MEMORANDUM

REVIEW TYPE: Preliminary Plan of Subdivision, Resubdivision of 2 Lots and 1 Part of Lot

PROJECT NAME: Garrett Park

CASE #: 1-06016

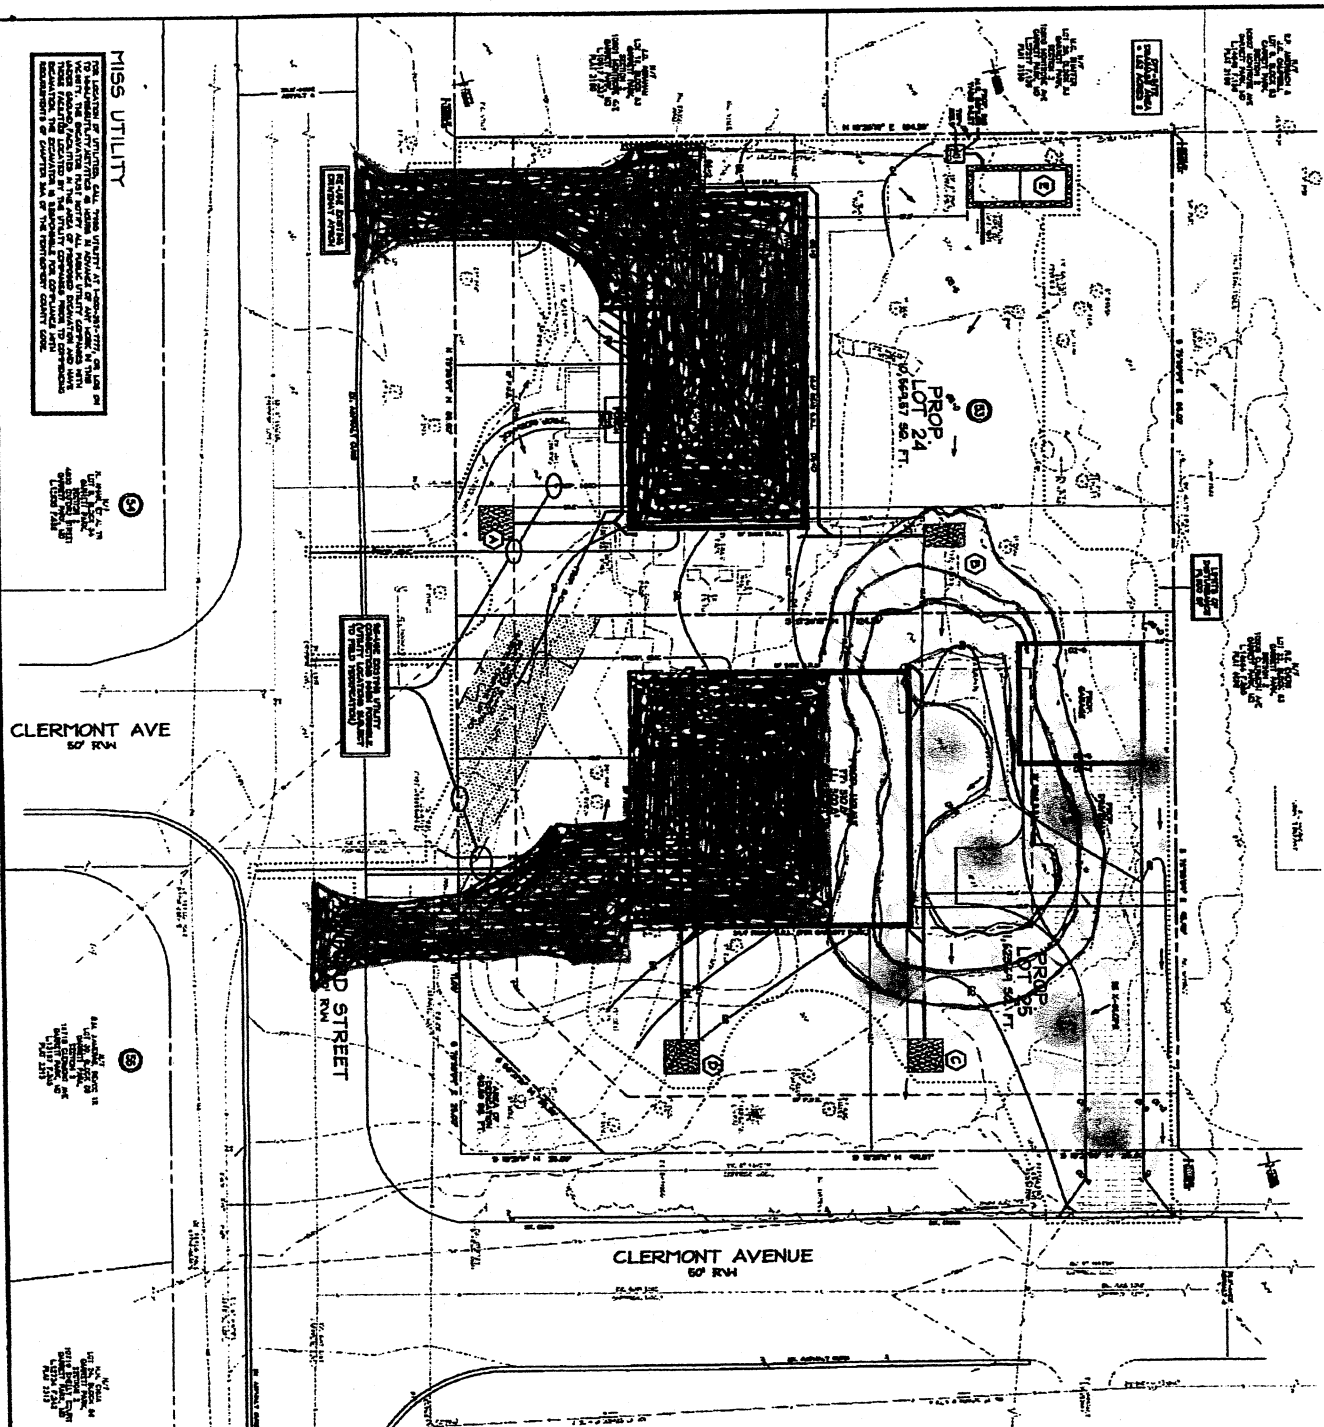
I strongly urge you to reject the proposed plan for the above resubdivision contained in the staff report dated Feb. 17, 2006. This plan is attached as Exhibit A and shows the huge area of impervious surface in red.

The plan, as currently proposed, would result in 2 large "McMansions", with at least one having a large 2 car garage (which could be 2 stories high) sitting virtually (5 feet away) on top of the neighboring property (which I own). The resulting lots would be almost denuded of trees and the tree canopy destroyed. The natural topography would be obliterated, with a large increase in impervious surface and the resulting drainage problems. The proposed plan would invade my privacy and destroy the quite enjoyment of my property and its value.

Violates Garrett Park Regulations—Garrett Park regulations provide that, “A house situated on more than one lot may only be demolished or razed only if the site is replatted to a single lot.” Section 401-c-1. The applicant’s house sits on 2 lots of record. The natural evolution of this planned resubdivision and then demolition violates this regulation.

Inconsistent with Montgomery County Subdivision Ordinance regarding Preserving Trees and Natural Drainage—As described in detail in my attached letter, the proposed re-subdivision as proposed is inconsistent with the County's Subdivision ordinance in several major respects:

Does not meet Re-subdivision Standards-- There are special provisions that apply to a re-subdivision. There are numerous large lots in this area of Garrett Park. This proposed plan would create 2 small lots in an area of larger lots.

It is also an area of significant open space and tree cover, even on the smaller lots that do exist. The relationship of the scale of existing homes to their sites creates this happy result. The proposed site plan with its nearly complete grade-out would result in the loss of the majority of existing trees on the property. Two nearly barren lots in the midst of a very treed area would result. The size and shape of the footprints on the proposed plan clearly show houses that are inconsistent with the scale and character of the surrounding neighborhood. These inconsistencies were NOT addressed in the staff report.

The attached Exhibit B shows a plan which meets many of the concerns raised above:

- + A significantly greater number of trees are preserved, including 2 specimen sycamores because the area of disturbance is reduced substantially.
- + The natural drainage swale is respected.
- + The area of impervious surface is substantially reduced.
- + The privacy and quiet enjoyment of neighboring property owners is respected.
- + In addition, it provides proper backyards for family life for both houses.

If it is determined that a proposed re-subdivision can move forward, I urge the Board to adopt a plan consistent with the plan as outlined in Exhibit B and set conditions and standards which truly achieve the objectives of the Montgomery County ordinances, including the Garrett Park Overlay Zone.

EXHIBIT A - PROPOSAL

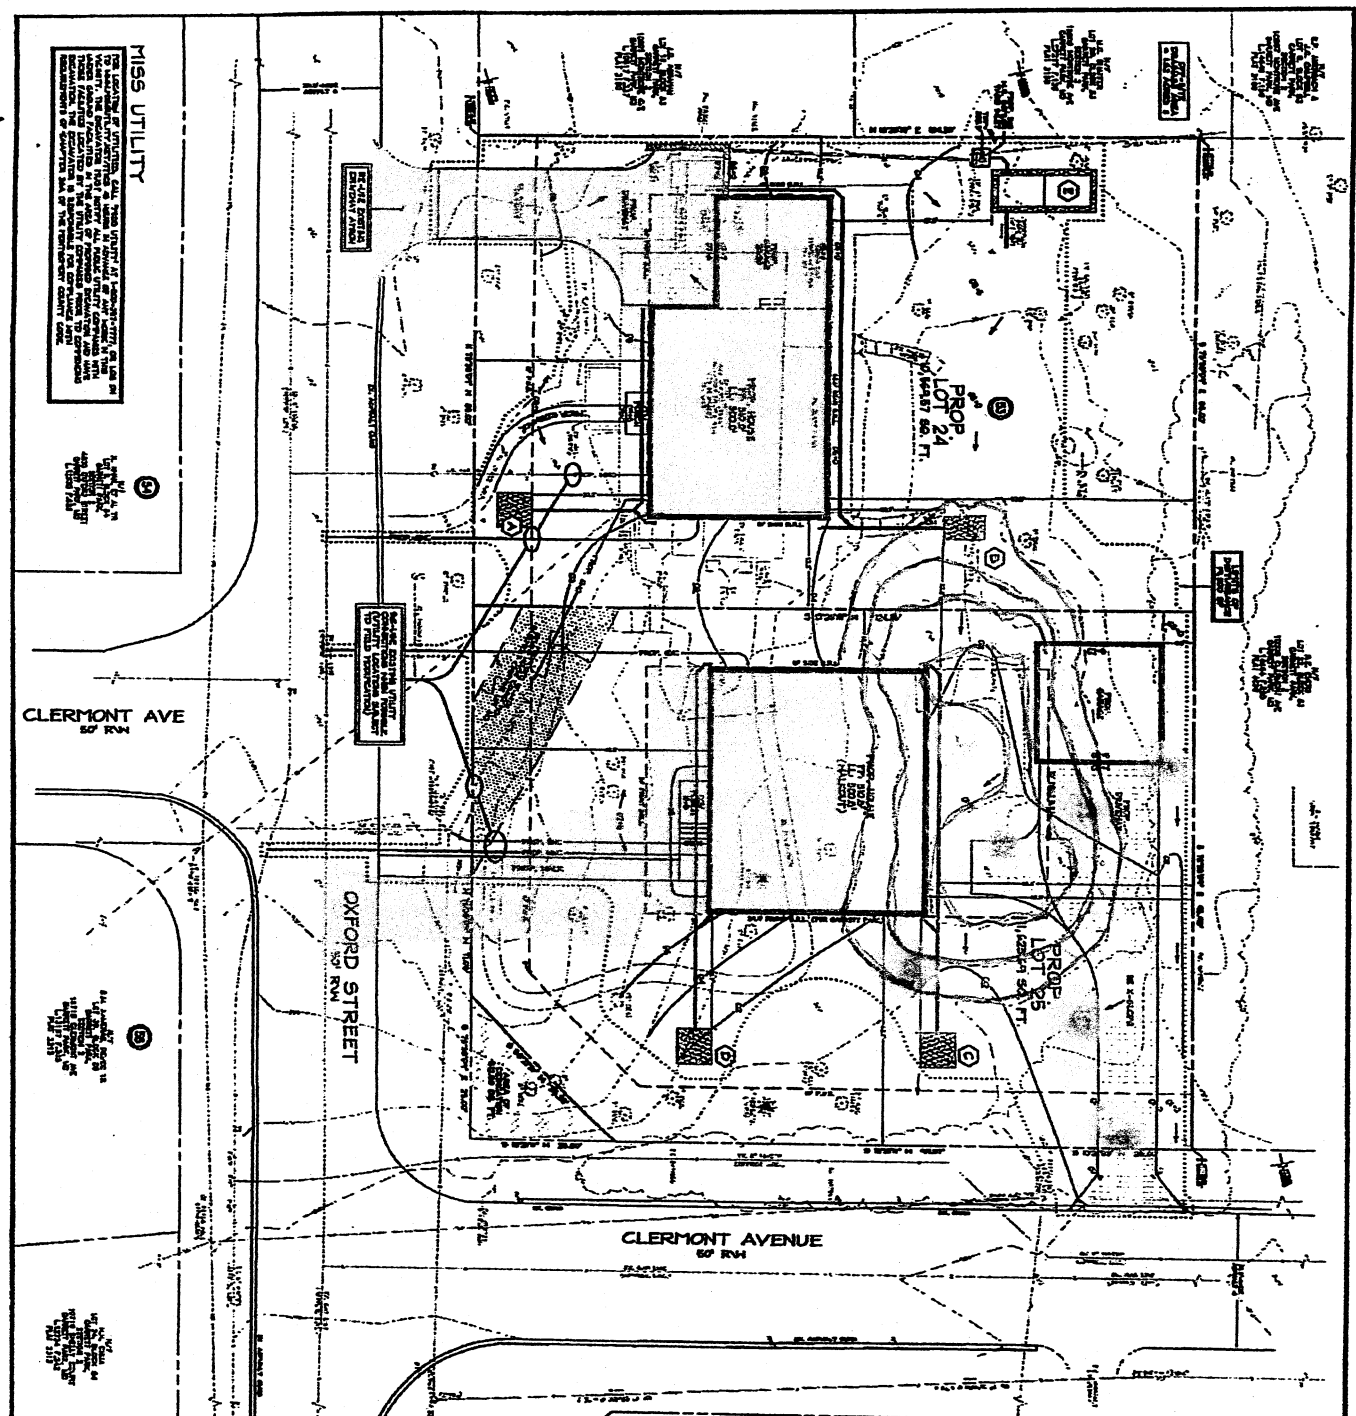
I strongly urge you to reject the proposed plan for the above resubdivision contained in the staff report dated Feb. 17, 2006. This plan is attached as Exhibit A and shows the huge area of impervious surface in red.

The plan, as currently proposed, would result in 2 large "McMansions", with at least one having a large 2 car garage (which could be 2 stories high) sitting virtually (5 feet away) on top of the neighboring property (which I own). The resulting lots would be almost denuded of trees and the tree canopy destroyed. The natural topography would be obliterated, with a large increase in impervious surface and the resulting drainage problems. The proposed plan would invade my privacy and destroy the quite enjoyment of my property and its value.

Violates Garrett Park Regulations—Garrett Park regulations provide that, “A house situated on more than one lot may only be demolished or razed only if the site is replatted to a single lot.” Section 401-c-1. The applicant’s house sits on 2 lots of record. The natural evolution of this planned resubdivision and then demolition violates this regulation.

Inconsistent with Montgomery County Subdivision Ordinance regarding Preserving Trees and Natural Drainage—As described in detail in my attached letter, the proposed re-subdivision as proposed is inconsistent with the County's Subdivision ordinance in several major respects:

Does not meet Re-subdivision Standards-- There are special provisions that apply to a re-subdivision. There are numerous large lots in this area of Garrett Park. This proposed plan would create 2 small lots in an area of larger lots.

It is also an area of significant open space and tree cover, even on the smaller lots that do exist. The relationship of the scale of existing homes to their sites creates this happy result. The proposed site plan with its nearly complete grade-out would result in the loss of the majority of existing trees on the property. Two nearly barren lots in the midst of a very treed area would result. The size and shape of the footprints on the proposed plan clearly show houses that are inconsistent with the scale and character of the surrounding neighborhood. These inconsistencies were NOT addressed in the staff report.

The attached Exhibit B shows a plan which meets many of the concerns raised above:

If it is determined that a proposed re-subdivision can move forward, I urge the Board to adopt a plan consistent with the plan as outlined in Exhibit B and set conditions and standards which truly achieve the objectives of the Montgomery County ordinances, including the Garrett Park Overlay Zone.
